A123 SYSTEMS JSP17-21

Public Hearing at the request of Etkin, LLC for approval of Preliminary Site Plan, Woodland Permit, and Stormwater Management Plan. The subject parcel is located in Section 15, West of Cabaret Drive and South of Twelve Mile Road and is zoned OST, Office Service Technology. The applicant is proposing to develop the 31.25 acre parcel to two buildings: one office/lab space of 128,936 square feet and the other as assembly building of 53,469 square feet including associated site improvements.

PLAN REVIEW CENTER REPORT

Preliminary Site Plan

FIGURE 6
SIGHT DISTANCE
FOUNTAIN OFFICE PARK TIS - NOVI, MI

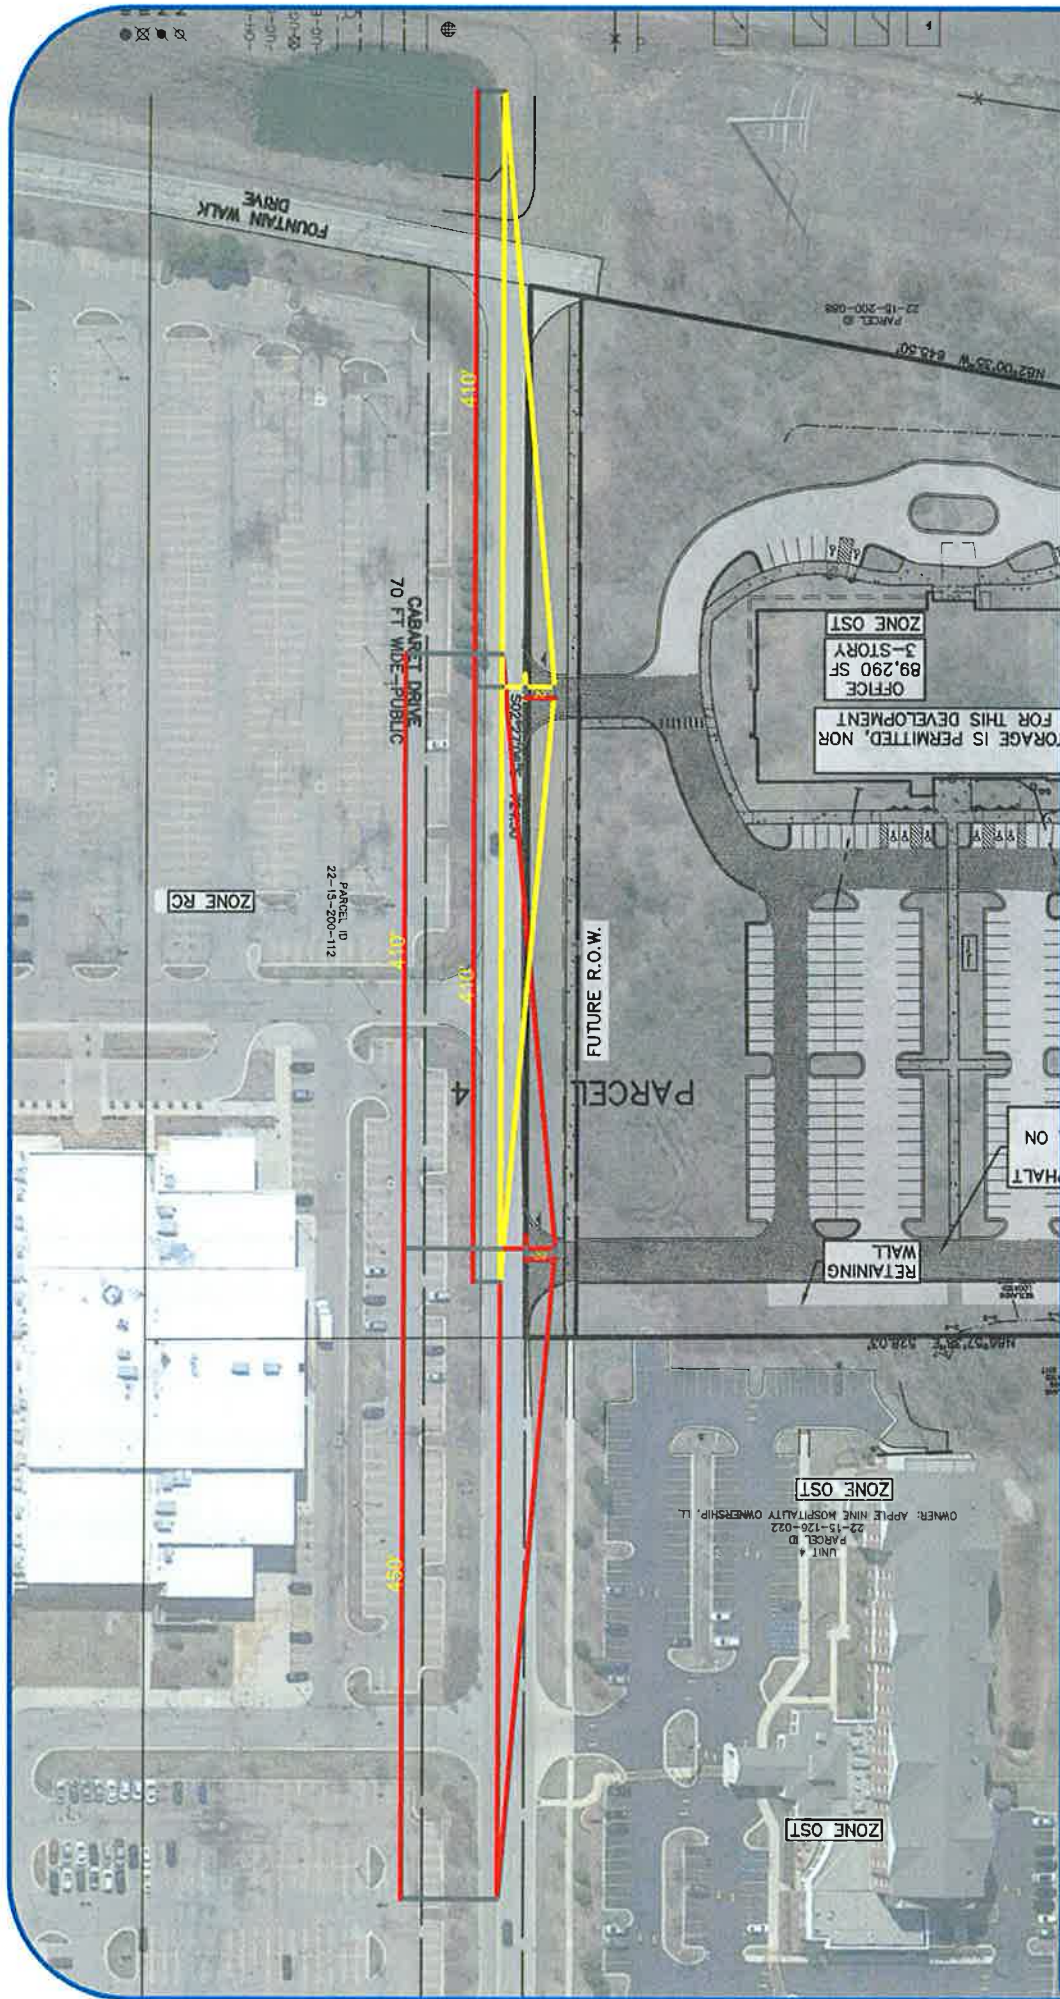
The City of Novi intersection sight distances were reviewed. The speed limit on Cabaret Drive is 40 mph, therefore a clear sight line of 410 feet is required at both proposed site driveways. Cabaret Drive is generally straight and flat adjacent to the proposed site, therefore the sight distance evaluation essentially evaluated clear vision at the site driveways, as illustrated on Figure 6. The results shows that there is adequate sight distance at the proposed site access drives.
